**RE: WSU MILPERRA – 2 AND 2A BULLECOURT AVENUE, MILPERRA (SSD-97092958)
TRAFFIC RESPONSE TO DPHI COMMENTS**

This letter provides a response to the comments provided by the Development Assessment and Sustainability of Department of Planning, Housing and Infrastructure (DPHI) in its email dated 22 April 2026.

**RE: 2 & 2A BULLECOURT AVENUE, MILPERRA
STATE SIGNIFICANT DEVELOPMENT 97092958
TRAFFIC RISK ASSESSMENT**

Drawing Title
INTERSECTION DETAILS
SHEET 3 OF 3

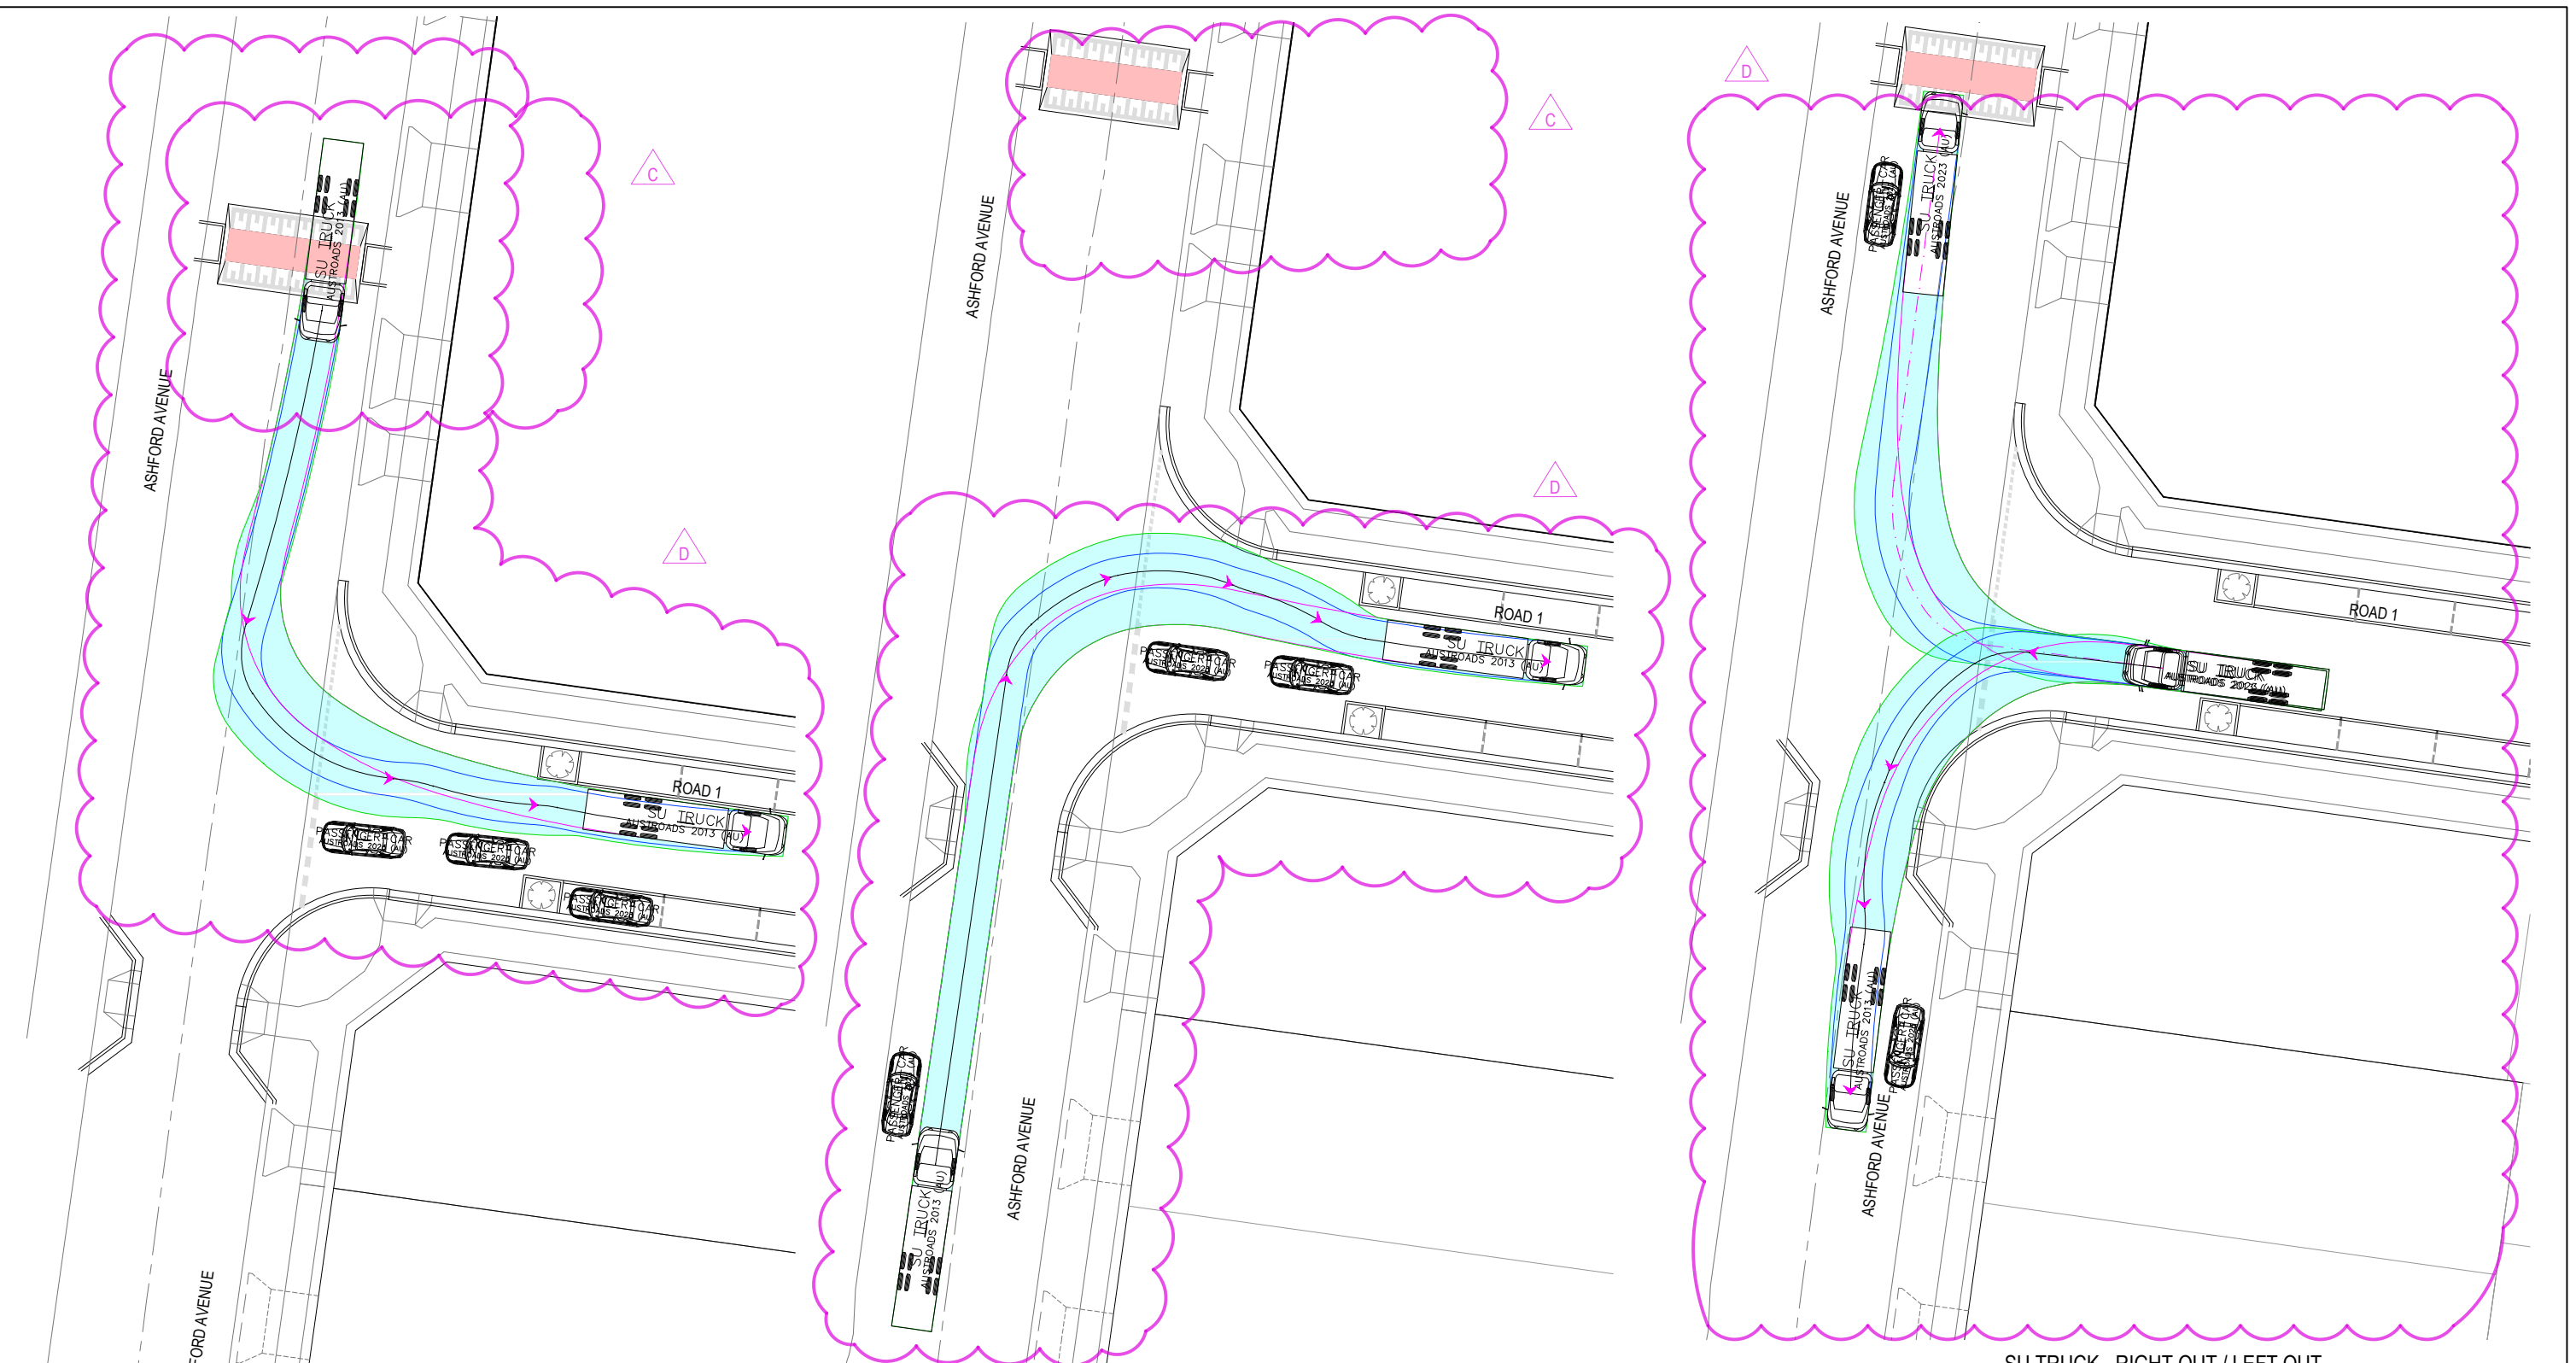
DPHI's Comments	TTPP Response
	A.2 Design and check vehicles  Figure A.2 – Check vehicles should be allowed to cross the centre of a carriageway when turning on local streets where no centreline is marked (Source: NACTO, Urban Street Design Guide)
Horsley Road Intersection - Retention of the existing road alignment and roundabout, with amendments to the footpath location to reduce impacts on the C2 zoned land is noted. - This design requires the introduction of multiple turning restrictions, including limiting access to the opposite property, and forces pedestrians to deviate from their natural desire lines. While individual design elements may technically comply with relevant standards, the scheme does not deliver a coherent and effective overall design outcome. - Additional details, or modification of the design to ensure the arrangement results in a safe and effective outcome for vehicles and pedestrians is required.	Regarding the impact on access to the opposite property, it is assumed that the comment refers to the opposite property on Horsley Road (i.e. #270 Horsley Road). It should be noted that the existing driveway on the eastern side of the roundabout will be removed under the development approval (SSD-51147710) of the opposite property. Therefore, the proposed Horsely Road access intersection design has no impact on the access of surrounding properties. In terms of the pedestrian access along the northern side of the exit roadway of Road 2B, it is noted that the northern verge area adjacent to the exit roadway is located within the C2 Environmental Conservation zone, and therefore any works must seek to minimise disturbance to the area. As a result, a paved pedestrian footpath is not permitted within the C2 zone. The original SSDA civil plans propose a footpath on the centre island on Road 2B at the intersection, connecting the footpath on the northern side of Road 2B and the existing footpath on the western side of Horsley Road. However, pedestrians would need to cross Road 2B twice when walking between the site and Horsley Road north of the roundabout.

DPHI's Comments	TTPP Response
	Alternatively, a raised boardwalk is proposed within the area connecting the footpath on the northern side of the new access road to the existing footpath on the western side of Horsley Road, as shown in the figure below. The boardwalk will facilitate a controlled and desired pedestrian connection between the development frontage and the surrounding pedestrian facilities. Signage can be provided on the footpath on Horsley Road before crossing the exit roadway, to guide pedestrians to walk through the boardwalk and cross at the pram ramp on Road 2B. The boardwalk will comprise a raised pathway structure designed to traverse the conservation area while minimising impacts to existing vegetation, ground conditions, and ecological values. The raised design also reduces the need for bulk earthworks and allows natural drainage patterns and ground-level habitats to be preserved. The design will consider tree root mapping undertaken within the corridor, with particular consideration given to the structural root zones (SRZ) of adjacent trees. The alignment and support locations of the boardwalk will be developed to ensure that any structural encroachments are avoided or minimised, with all primary footings positioned outside defined tree structural roots where practicable.

DPHI's Comments	TTPP Response
	From an engineering standpoint, the structure will be designed to ensure durability, constructability, and minimal maintenance, with appropriate consideration given to footing solutions and selected materials to suit the C2 Environmental Conservation zone. Overall, the proposed boardwalk serves as a key mitigation measure in addressing the pedestrian connectivity, by encouraging pedestrian movement along a defined and safer route separated from vehicular traffic, while avoid deviating pedestrian from their natural desire lines. Notwithstanding that above, an independent risk assessment has been undertaken by PDC Consultants assessing the differences between the two Horsley Road intersection designs. It is concluded in the risk assessment report that the updated design with the boardwalk provides an improved outcome for pedestrians, by minimising the number of conflict points when walking north-south on Horsley Road. The risk assessment report is provided in Attachment Two.

Figure 1: SSDA Design 1

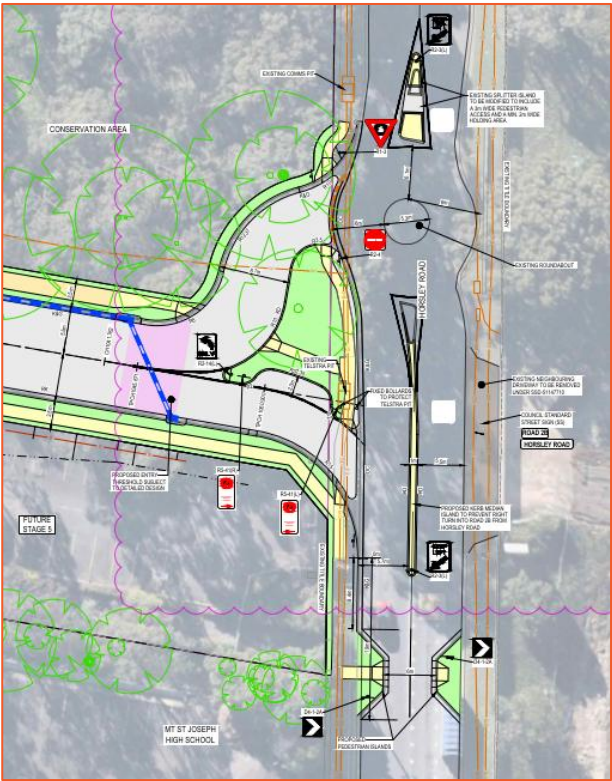
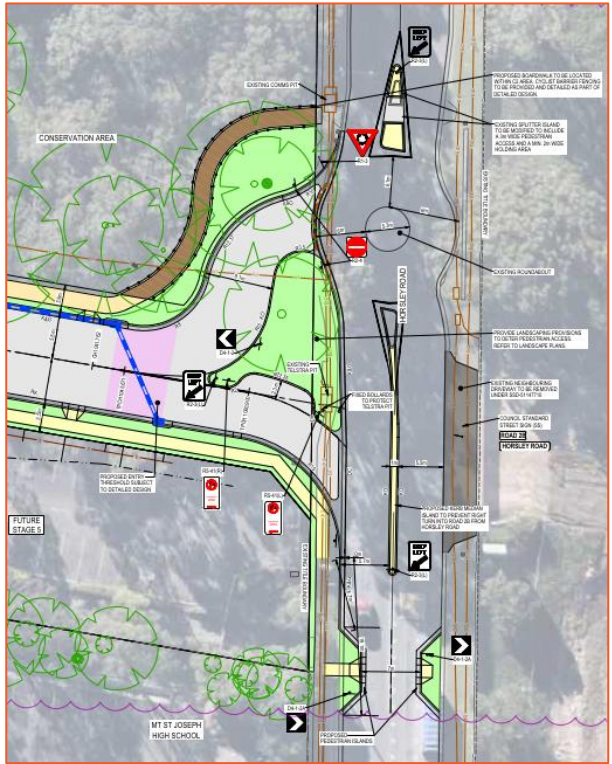
- *This design requires the introduction of multiple turning restrictions, including limiting access to the opposite property, and forces pedestrians to deviate from their natural desire lines. While individual design elements may technically comply with relevant standards, the scheme does not deliver a coherent and effective overall design outcome.*
- *Additional details, or modification of the design to ensure the arrangement results in a safe and effective outcome for vehicles and pedestrians is required.”*

ITEM	LOCATION	ROAD SAFETY FINDING	LIKELIHOOD	SEVERITY	LEVEL OF RISK
1	Left turn entry	The design of the left turn entry lane from Horsley Road appears to enable a relatively high entry speed when entering Road 2B. The higher speed upon entry has potential to increase the severity of a crash in this location. There are a number of potential crashes in this location, including: - Rear-end or side-swipe crashes with vehicles in what appear to be an indented parking bay for vehicles. - The pedestrian movements at the pram ramp between the southern kerb of Road 2B and the central island area between the entry and exit lanes on Road 2B. 	Unlikely	Minor	Low
2	Vehicle queuing	The location of the pram ramp on Road 2B, approaching the roundabout, is located in close proximity to the roundabout. In the event of vehicle queuing, a pedestrian will need to walk within Road 2B to go around the queued vehicle and may even step within Horsley Road to pass the queued vehicle. There is a risk of vehicle to pedestrian crashes based on the pedestrian movements in this location, and the need for the pedestrian to walk within the roadway around vehicles. It is noted that under existing conditions, the western approach to the roundabout is a driveway where vehicles are legally required to give-way to pedestrians.	Rare	Moderate	Low

ITEM	LOCATION	ROAD SAFETY FINDING	LIKELIHOOD	SEVERITY	LEVEL OF RISK
		- There is reduced sight lines to queuing at the Road 2B approach to the roundabout. There is a risk of rear-end crashes.

ITEM	LOCATION	ROAD SAFETY FINDING	LIKELIHOOD	SEVERITY	LEVEL OF RISK
1	Left turn entry	The design of the left turn entry lane from Horsley Road appears to enable a relatively higher entry speed when entering Road 2B. The higher speed upon entry has potential to increase the severity of a crash in this location particularly rear-end or side-swipe crashes with vehicles in what appear to be an indented parking bay for vehicles. 	Unlikely	Minor	Low
2	Vehicle Queuing	The risk item identified under Design 1 has been addressed in Design 2, removing the conflict point and removes or reduces this risk.			
3	Footpath Intersection	The risk item identified under Design 1 has been addressed in Design 2, removing the conflict point and removes or reduces this risk.			
4	Share path design	The risk item identified under Design 1 has been addressed in Design 2, removing the conflict point and removes or reduces this risk.

5	Road 2B approach speeds	The risk item identified under Design 1 has been addressed in Design 2, with improved signage and messaging to the motorist. This removes or reduces this risk.			
6	Footpath Fencing	It is unclear what fencing treatment is proposed for the shared path through the conservation area. There is a risk of cyclist snagging on the fencing, or toppling over the fence when traversing through the conservation area <i>It is understood that the boardwalk design through the conservation area will be further developed as part of detailed design and include bicycle compliant fencing, significantly reducing the potential for snagging and falls.</i>	Unlikely	Minor	Low

The focus of this risk assessment is changes to the intersection and the introduction of Road 2B. The notable difference between Design 1 (**Figure 1**) and Design 2 (**Figure 2**) is the pedestrian footpath design and alignment. Design 2 routes the footpath away from the Horsley Road frontage.

Whilst Design 1 and Design 2 share common risk findings, the difference in the pedestrian footpath design and alignment under Design 2 provides an improved outcome for pedestrians, by minimising the number of conflict points when walking north – south on Horsley Road.
